Airport Moving Map Alert

Subject: Charlotte, North Carolina
Charlotte/Douglas Intl (KCLT)
Cycle 2603

TWYs layout incorrect.

JEPPESEN
 13 MAR 26 (10-9-0)

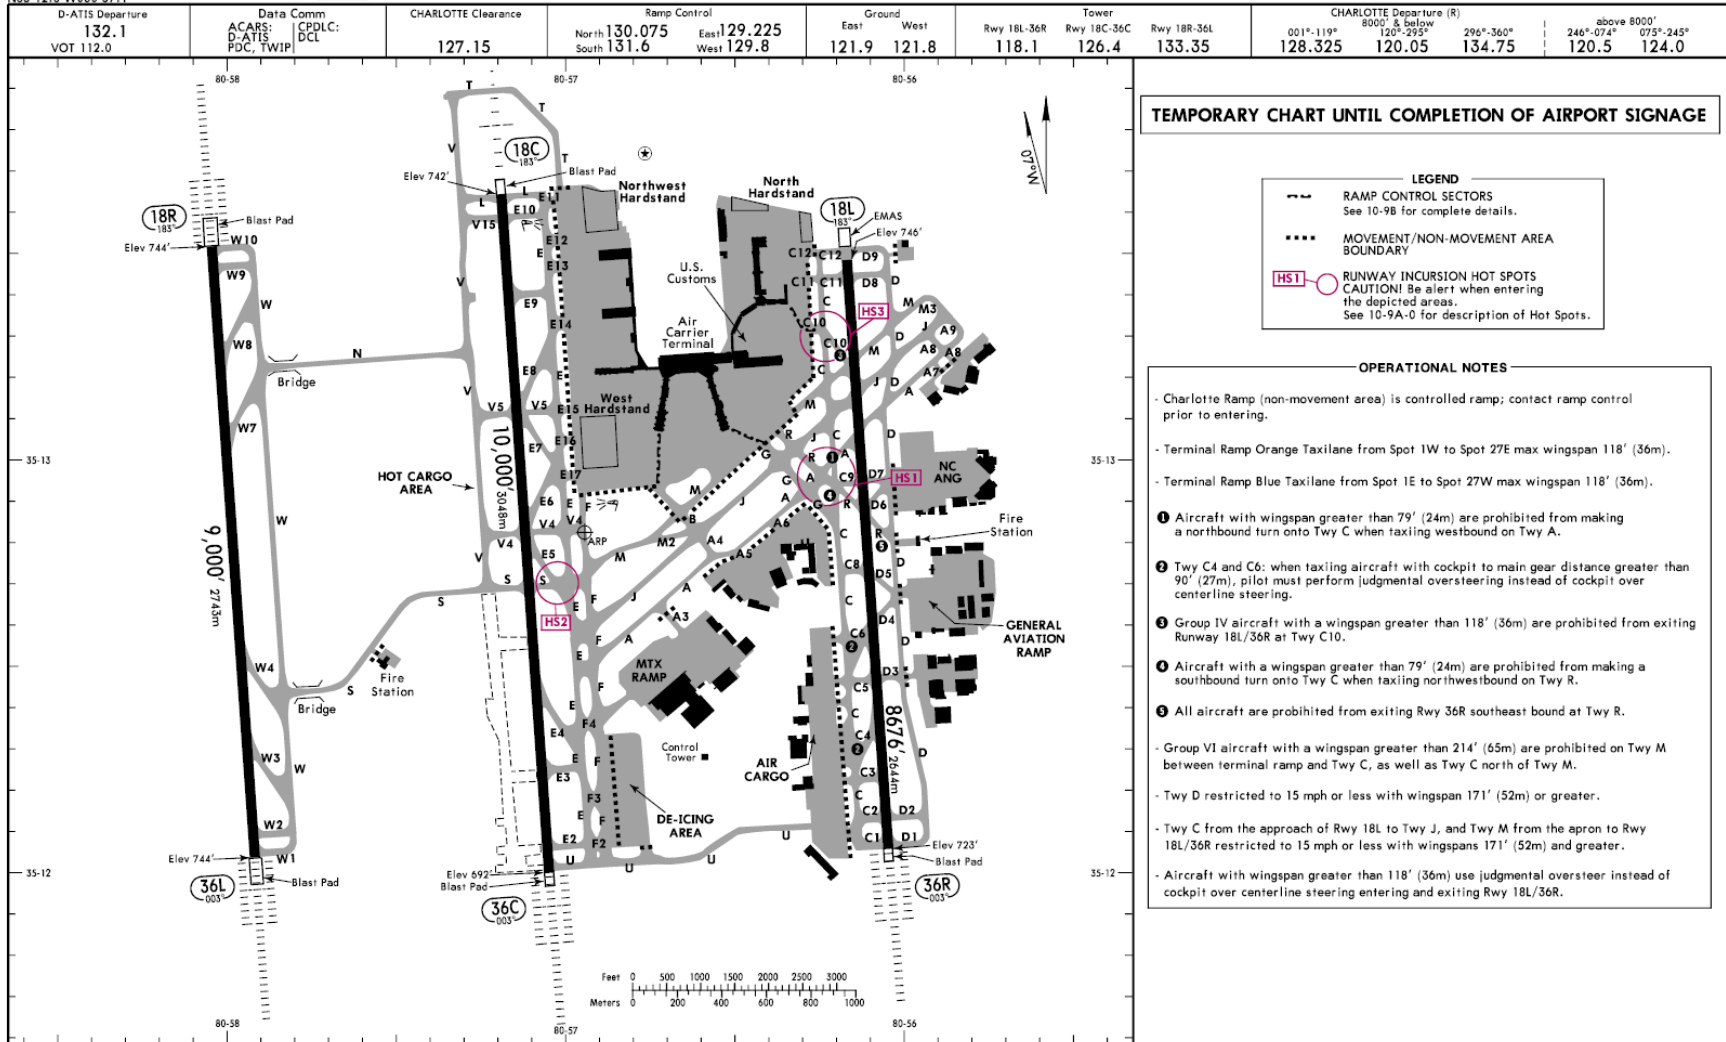
Jeppesen Airport Moving Map and A816 formatted data for cycle 2603, effective 19 March 2026, contain incorrect data for Charlotte/Douglas Intl; Charlotte, North Carolina (KCLT). NFDD 030, effective 19 March 2026, including a new airport layout with multiple TWY changes, has been postponed due to lack of the airfield signs required for the scheduled changes to the taxiway identifiers.

- TWY E1 (between TWY E and RWY 18C/36C) shall read TWY U
- TWY E4 shall read TWY E3
- TWY E5 shall read TWY E4
- TWY E6 shall read TWY E5
- TWY E7 shall read TWY E6
- TWY E8 shall read TWY E7
- TWY E9 shall read TWY E8
- TWY E10 shall read TWY E9
- TWY E11 shall read TWY E10
- TWY E12 (east of RWY 18C/36C) shall read TWY L
- TWY F5 (east of TWY E) shall read TWY V4
- TWY J4 (between TWY J and TWY M) shall read TWY B
- TWY J4 (between TWY A and TWY J) shall read TWY A4
- TWY Q (west of TWY E) shall read TWY V4
- TWY V11 shall read TWY V15
- TWY V12 (west of RWY 18C/36C) shall read TWY L
- TWY Y shall read TWY V5
- TWY Z1 shall read TWY E11
- TWY Z2 shall read TWY E12

- TWY Z3 shall read TWY E13
- TWY Z4 shall read TWY E14
- TWY Z5 shall read TWY E15
- TWY Z6 shall read TWY E16
- TWY Z7 shall read TWY E17
- TWY Z28 shall read TWY C10
- TWY Z29 shall read TWY C11
- TWY Z30 (west of TWY C) shall read TWY C12
- TWYs K, U2, V1, V2, V4 are closed
- TWY V (south of TWY S) is closed

Jeppesen Airport Moving Map and A816 formatted data for cycle 2604, effective 16 April 2026, will become valid on the estimated completion date 16 April 2026. Until then this Alert will be posted on the Jeppesen Web site: [Notices and Alerts](#). Please refer to the local NOTAMs and Charlotte, N Car (KCLT) 10-9-0 temporary chart dated 13 MAR 26 (effective 19 MAR 26) for valid information. Temporary chart will be available until the new signs are installed and new taxiway identifiers become effective.
